Anders Lasater Architects, Inc.
384 Forest Avenue, Suite 12
Laguna Beach, CA 92651
949.260.7837, Office
949.457.1827, Office
anders@anderslasaterarchitects.com

D'Eliscu Residence
013-2015
New Single Family Home
1011 Kings Road
Newport Beach, CA 92663

A6.5

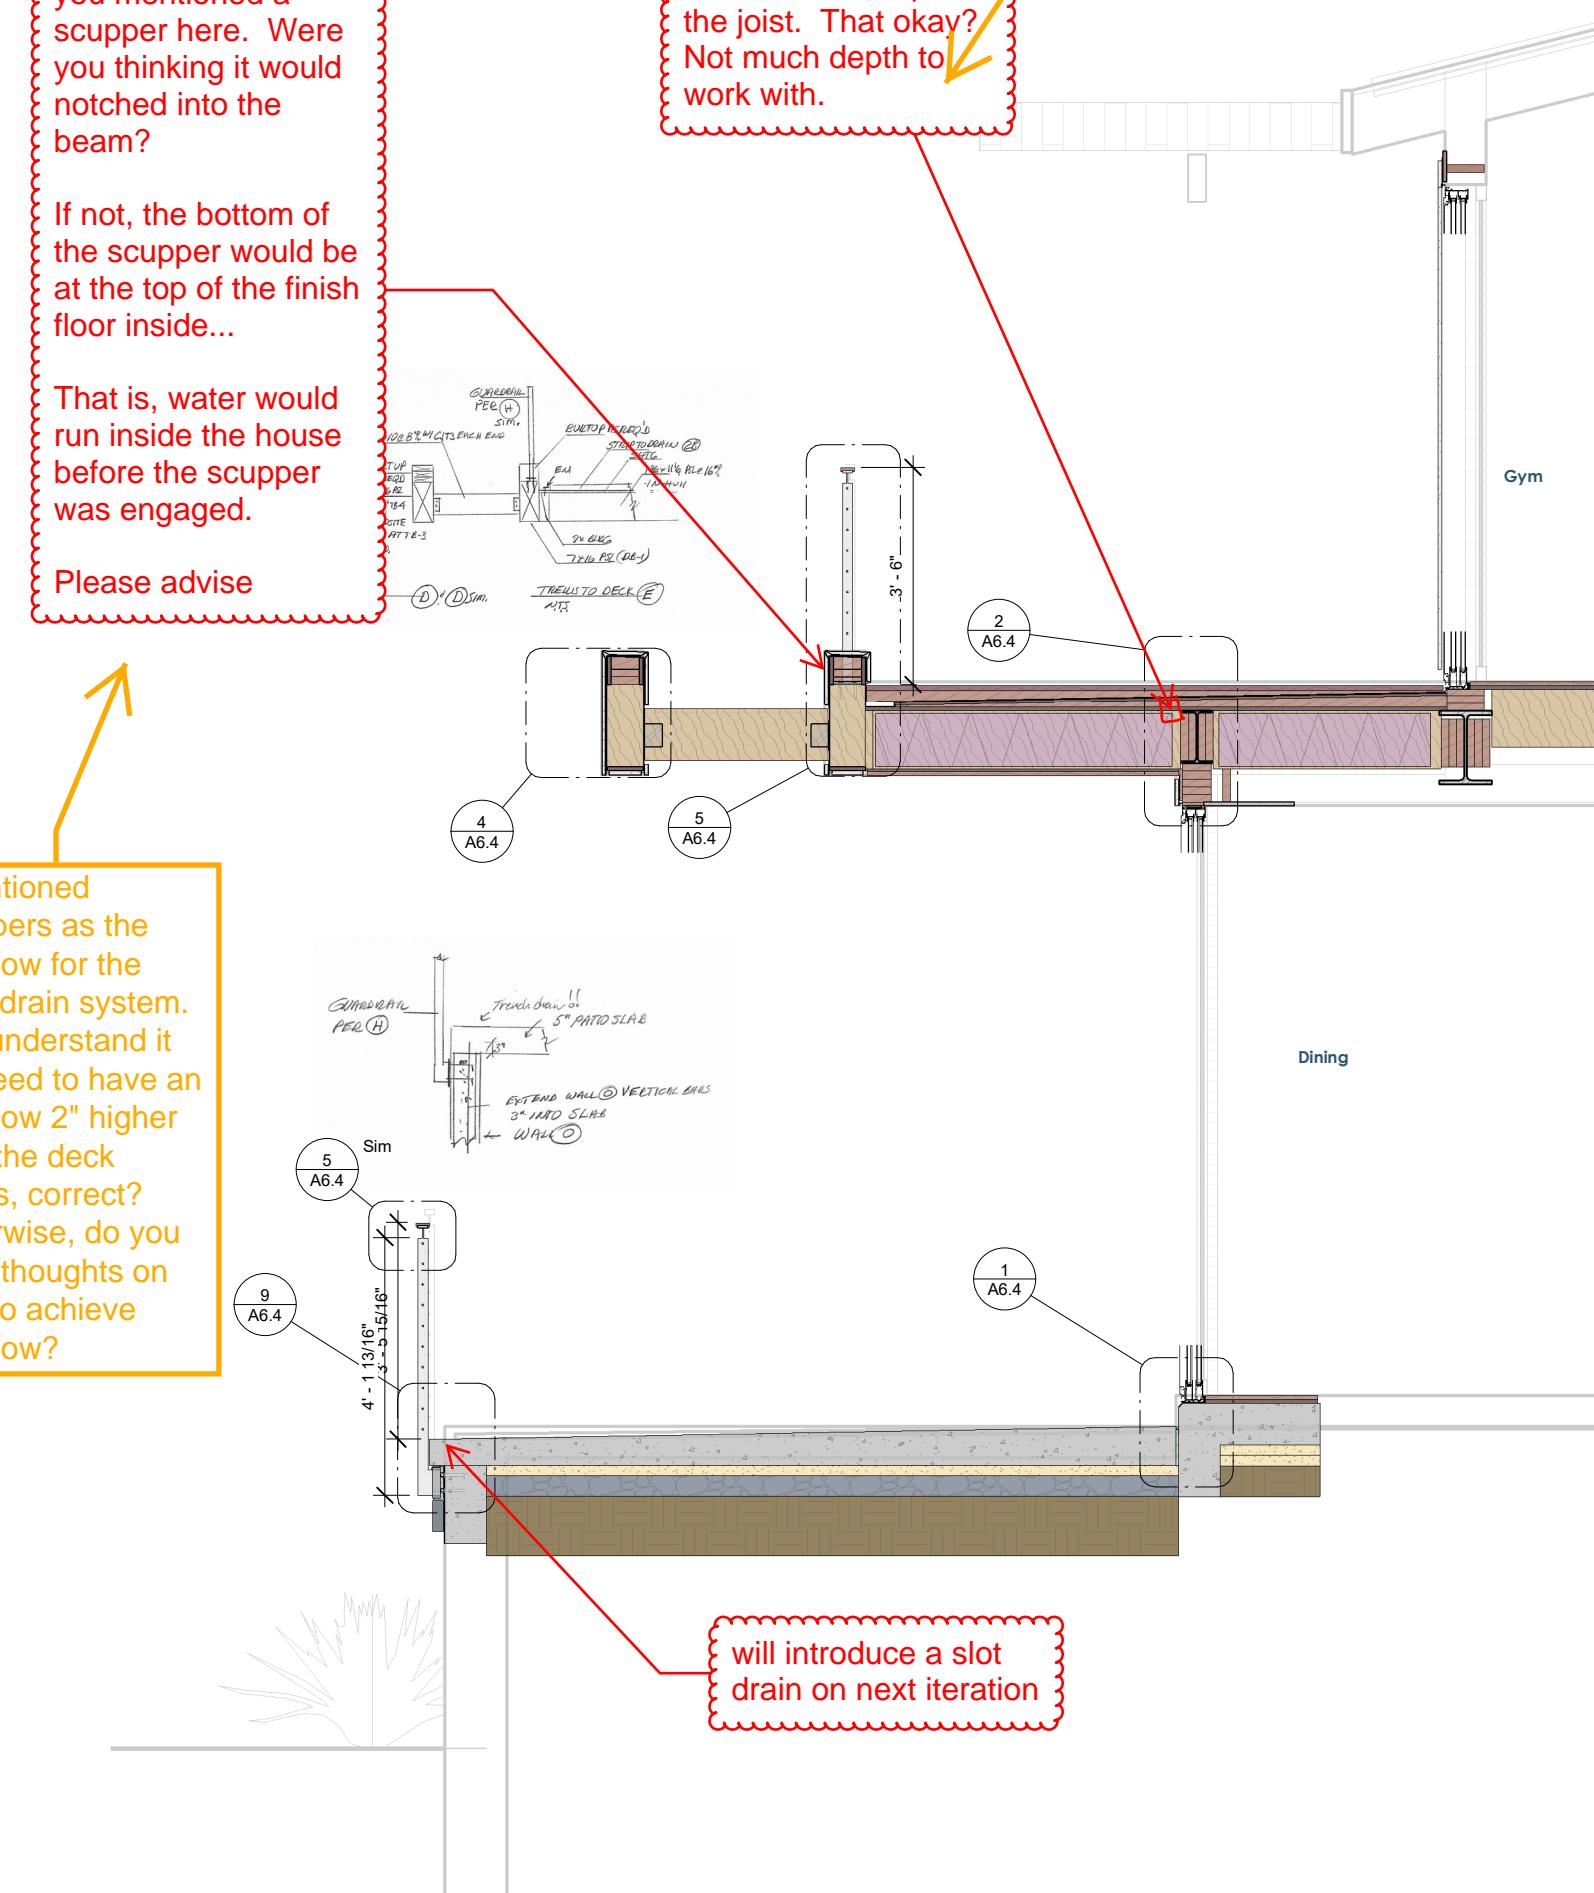
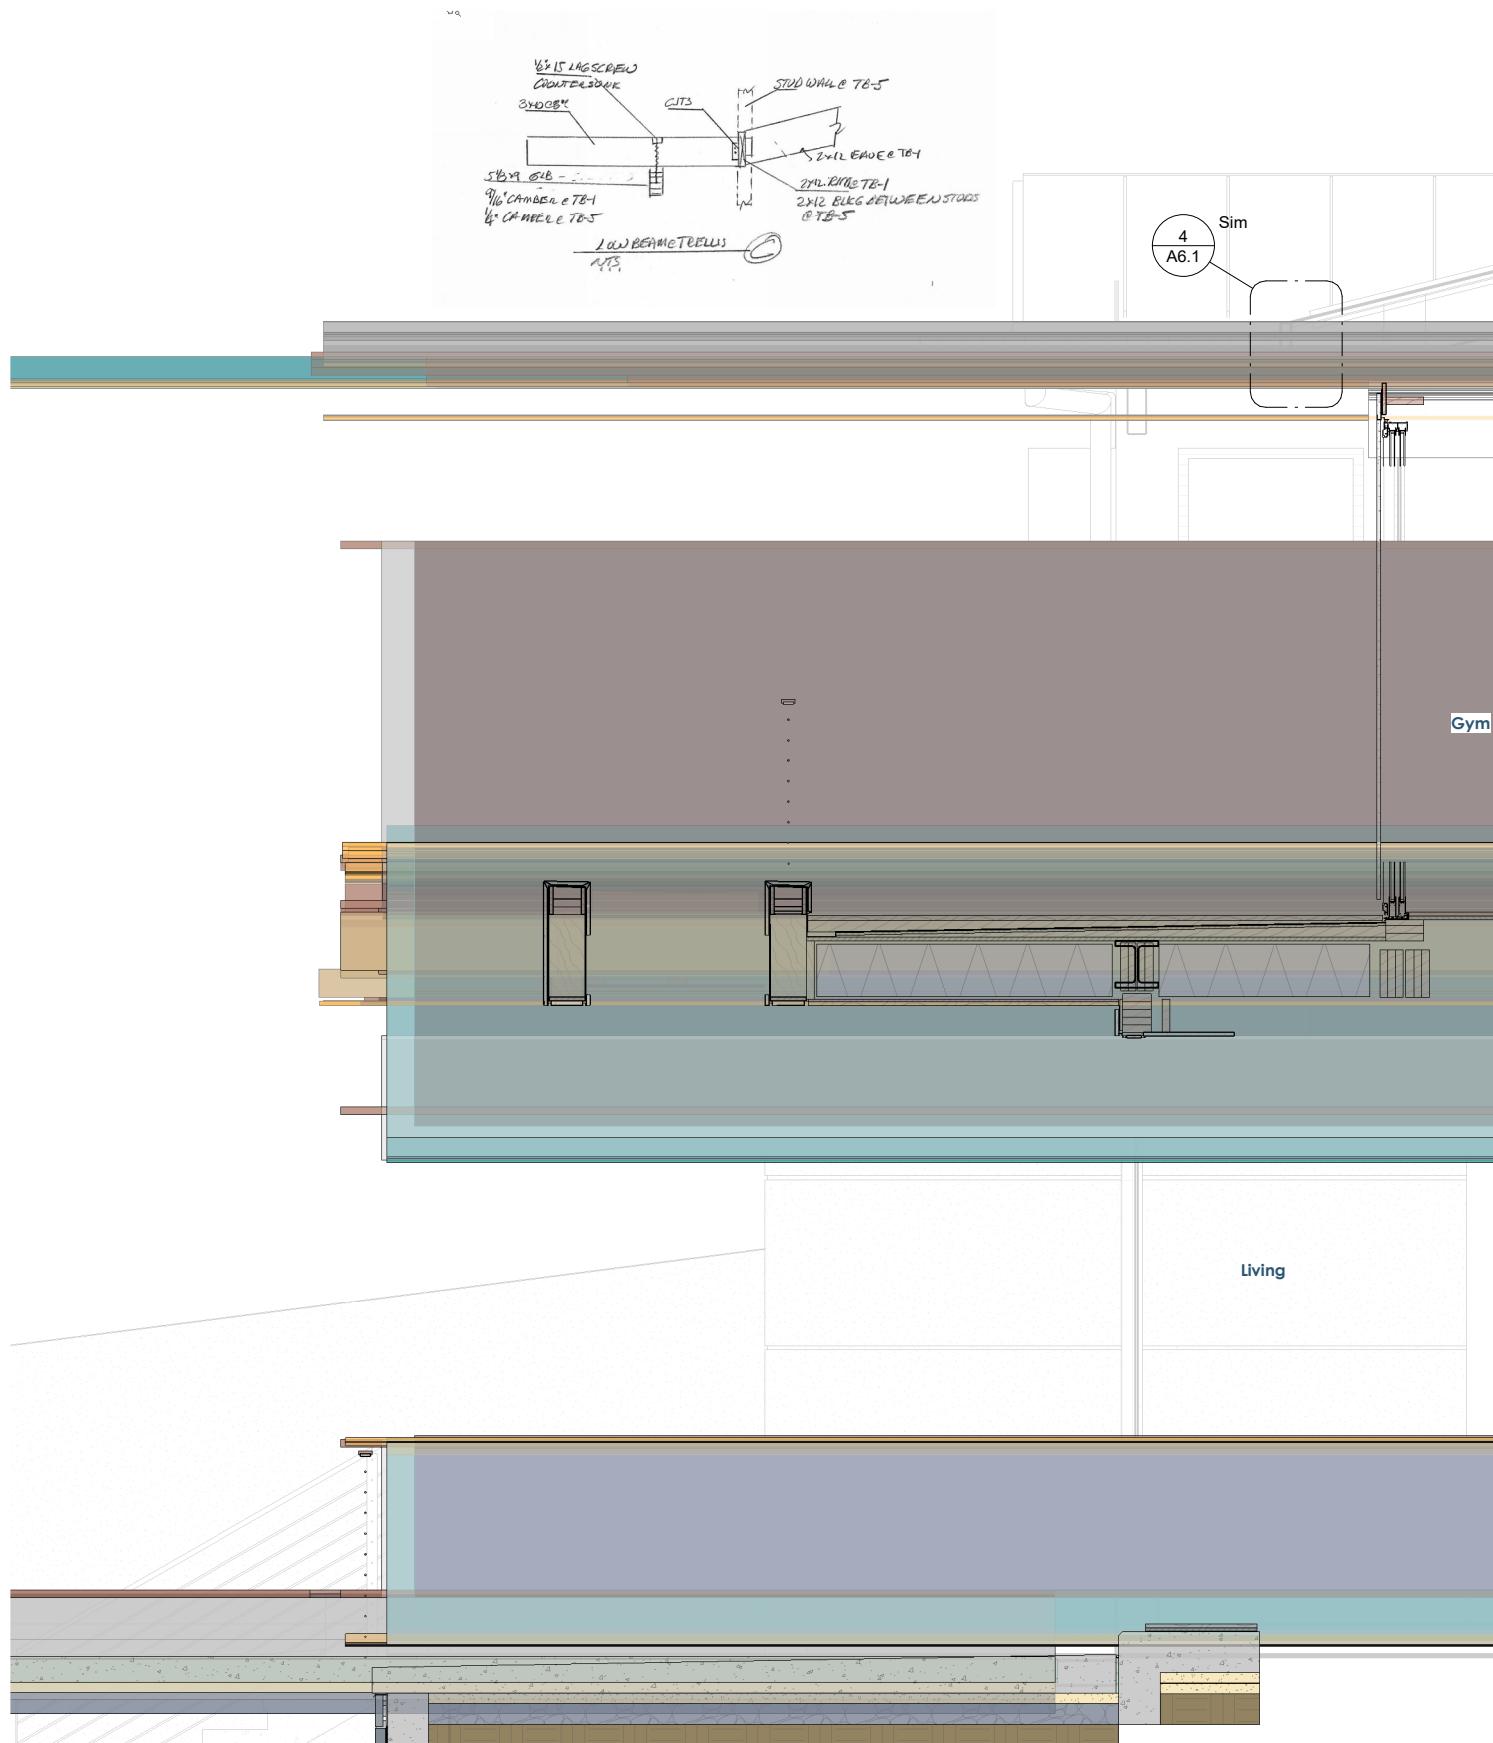
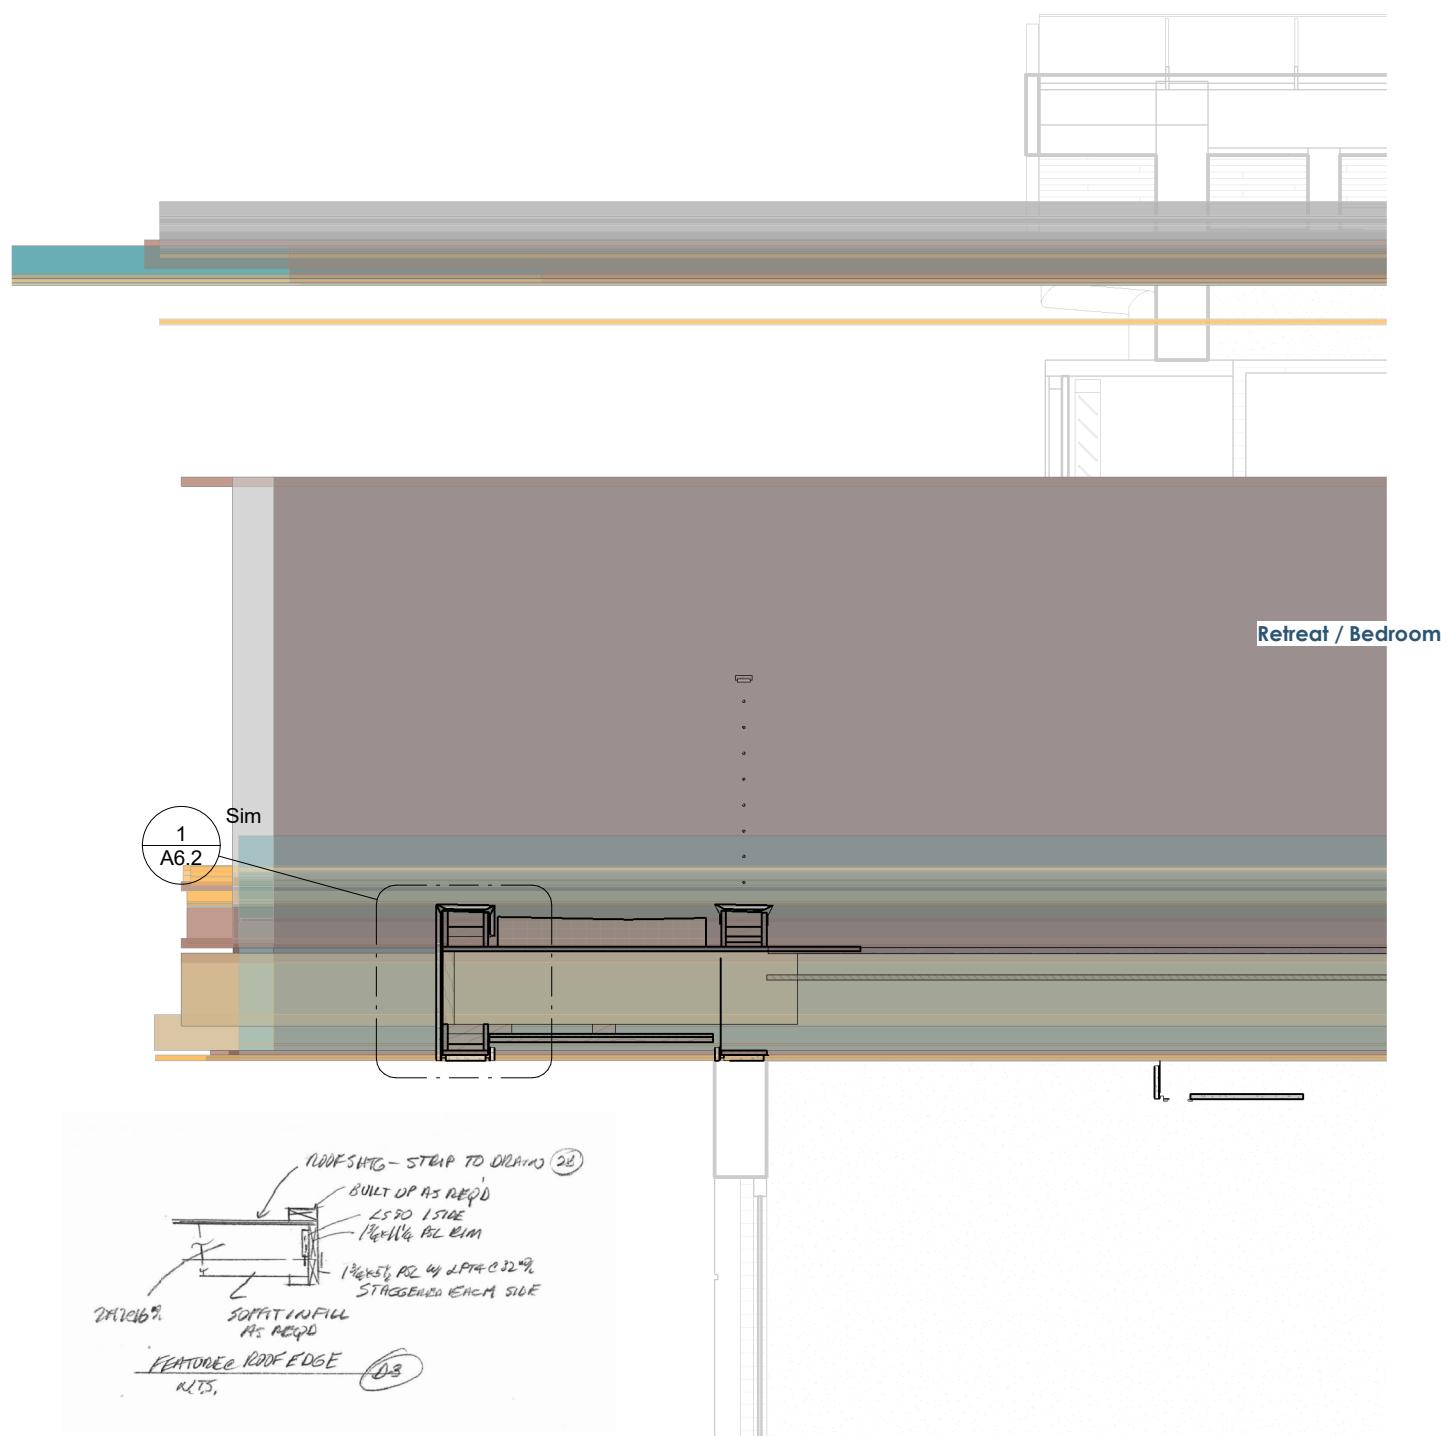
you mentioned a scupper here. Were you thinking it would notch into the beam?

If not, the bottom of the scupper would be at the top of the finish floor inside...

That is, water would run inside the house before the scupper was engaged.

Please advise

even if we locate a slot drain here, I think we might have to notch into the top of the joist. That okay? Not much depth to work with.

I mentioned scuppers as the overflow for the deck drain system. As I understand it we need to have an overflow 2" higher than the deck drains, correct? Otherwise, do you have thoughts on how to achieve overflow?

show it notched as needed for now. We can coordinate that with the engineer once we understand the depths needed. Thanks.

will introduce a slot drain on next iteration
